**Re: Response to Comments – Comment Letter Pre & Post Closure Groundwater Sampling Plan RTC (July 6, 2022)
Hess Corporation Former Port Reading Complex (HC-PR)
750 Cliff Road
Woodbridge, Middlesex County, New Jersey
NJDEP PI# 006148
ISRA Case No. E20130449
EPA ID No. NJD045445483**

Earth Systems, Inc. (Earth Systems) has prepared this letter on behalf of Hess Corporation (Hess) in response to the July 6, 2022 comment letter regarding the Pre & Post Closure Groundwater Sampling Plan Response to Comments (RTC) submitted by Hess and Earth Systems on April 22, 2022.

NJDEP Comments & Earth Systems/Hess Responses

April 1985 AWARE Inc. Drawings
(Comment 3)

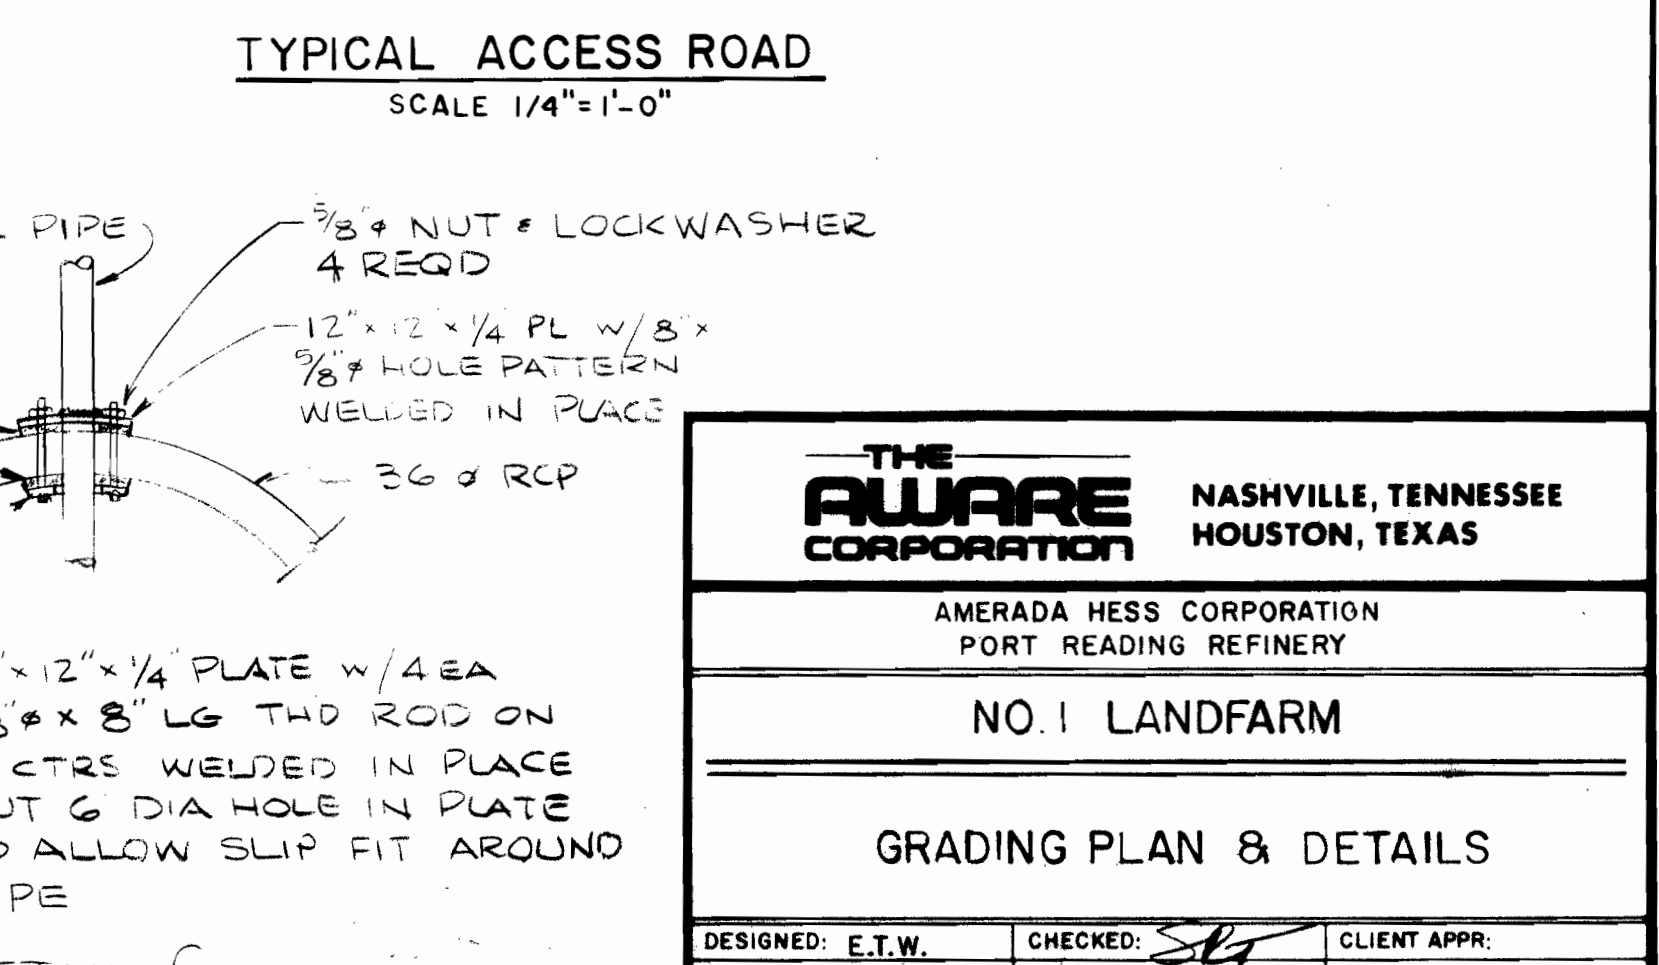
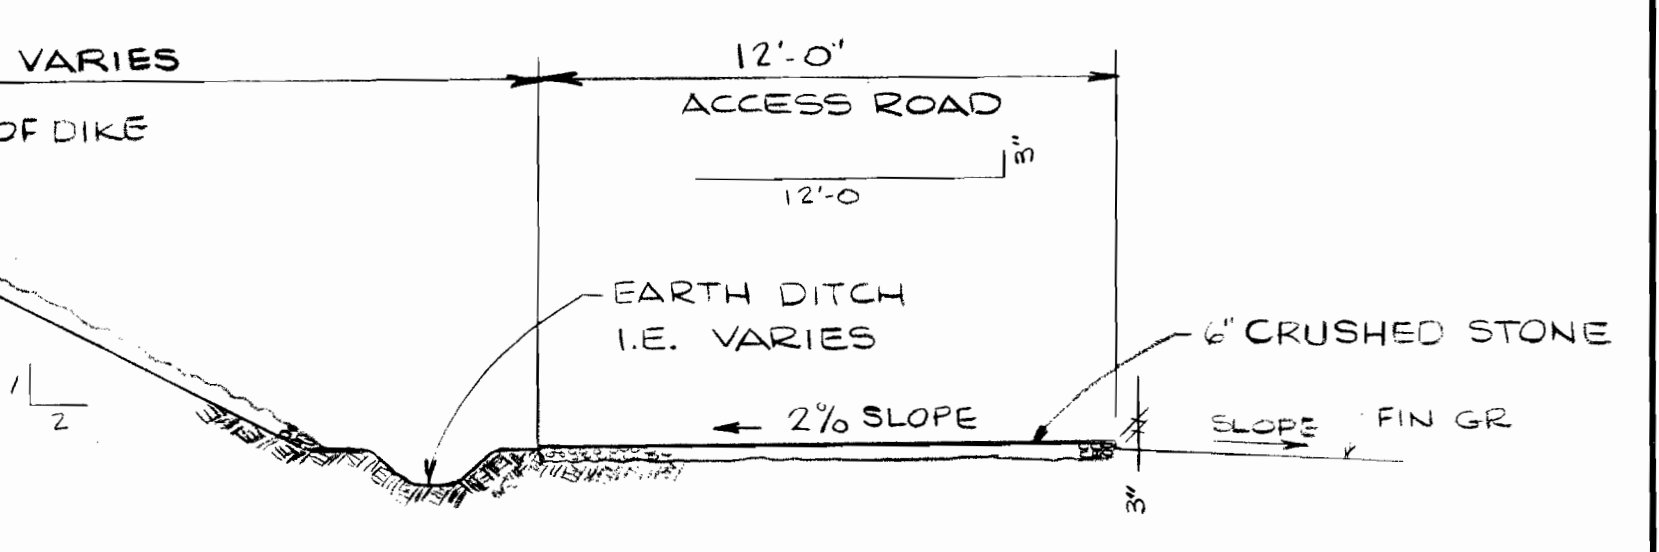
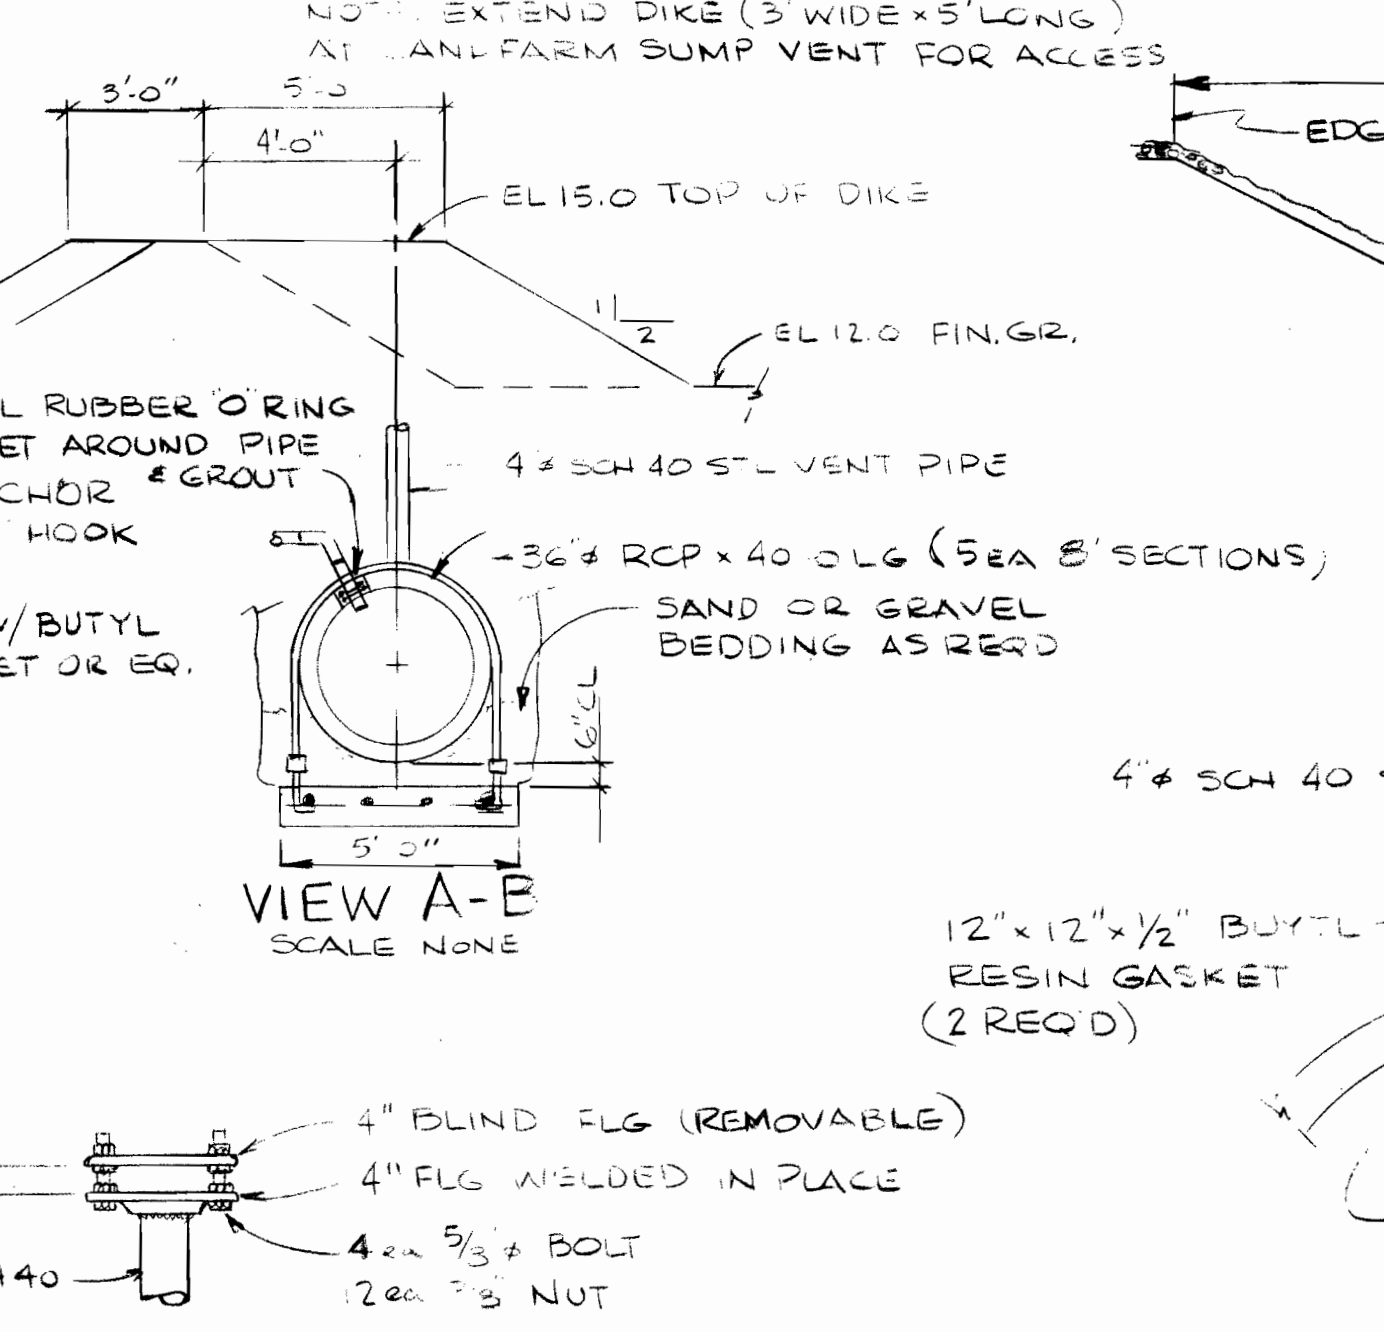
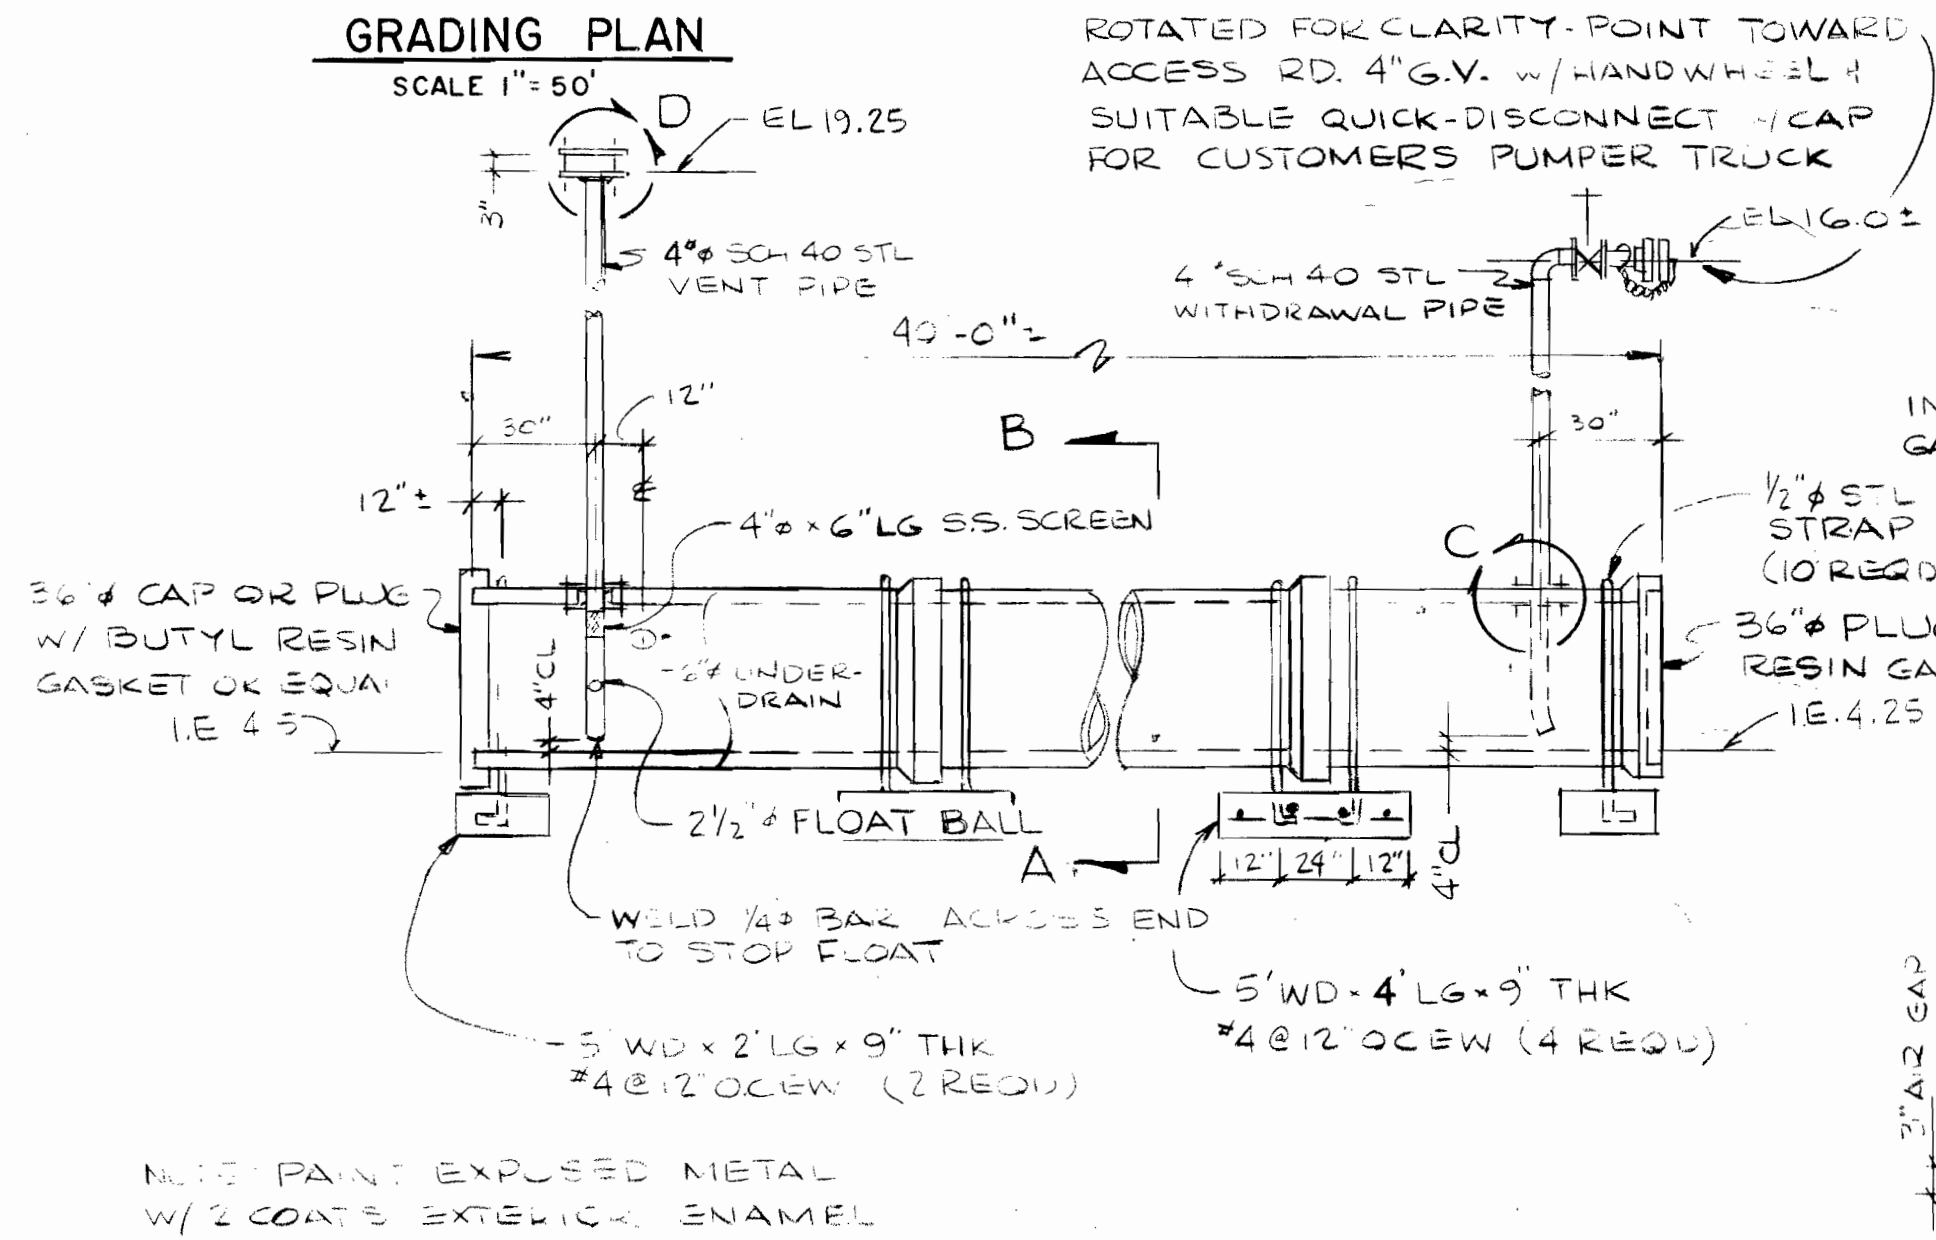
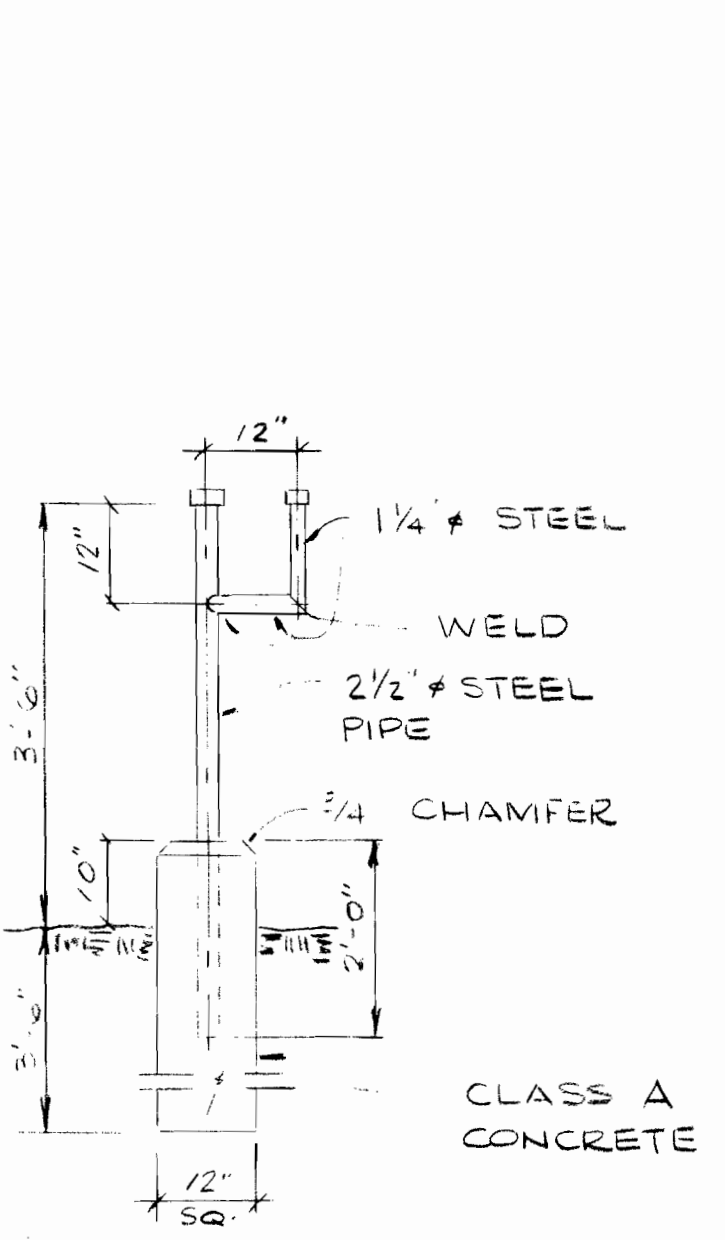
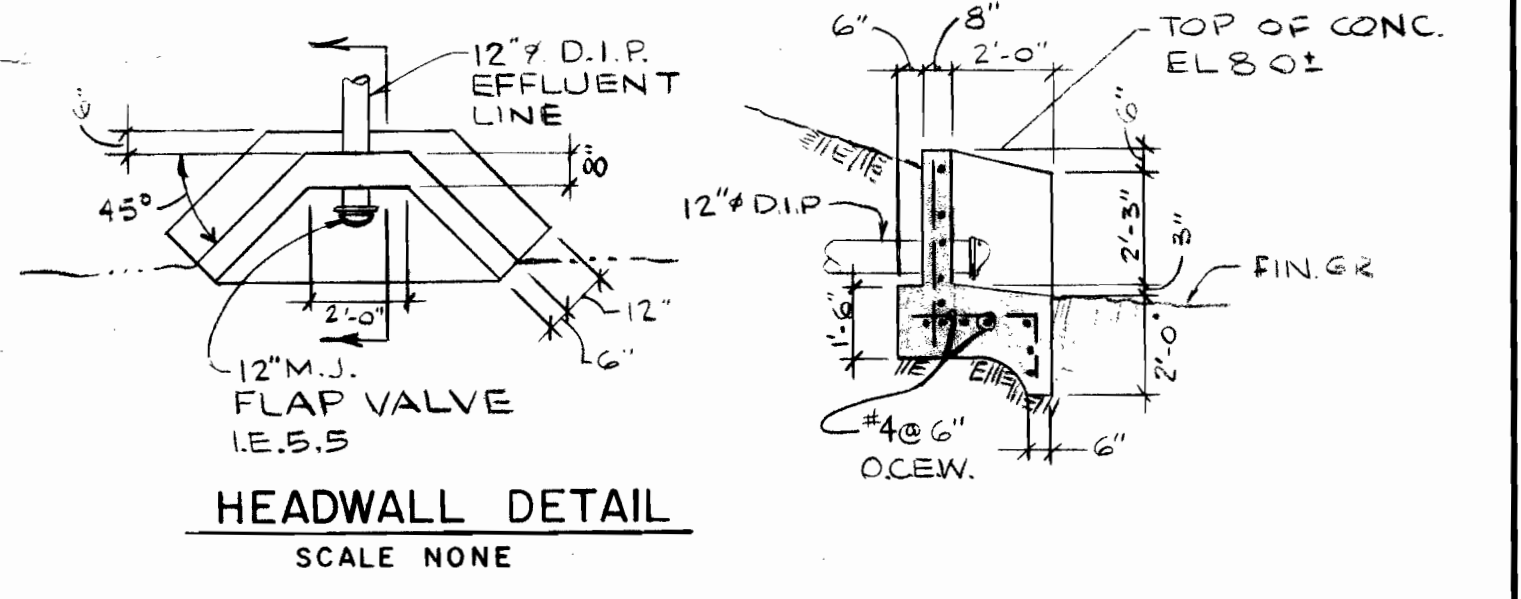
Existing well records/logs were provided as part of the response. Aware Corporation 1985 design drawings (provided with the November 1, 2019 response to comments on the 100% cap design for the No. 1 Landfarm) were not included with the response for future reference.

The AWARE 1985 design drawings will need to be included with the final No. 1 Landfarm GWSP. They should also be included with the RAR – Construction Complete Report for the No. 1 Landfarm capping.

The AWARE 1985 drawings have been included with this response.
